CITY OF CHARLOTTESVILLE

Department of Neighborhood Development Services

RE: Azalea Springs Final Site Plan 2nd Submission.

Sheet 1 (Cover)

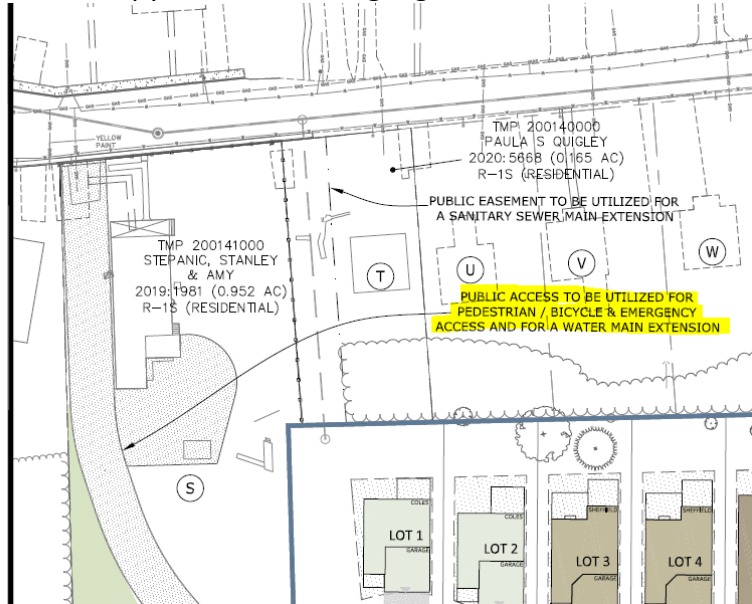
12. Note #2: The City's Utility Department has no record of reviewing or approving a public Utility easement over TMP 200140000. This will need to be addressed through the City's Utility Department.
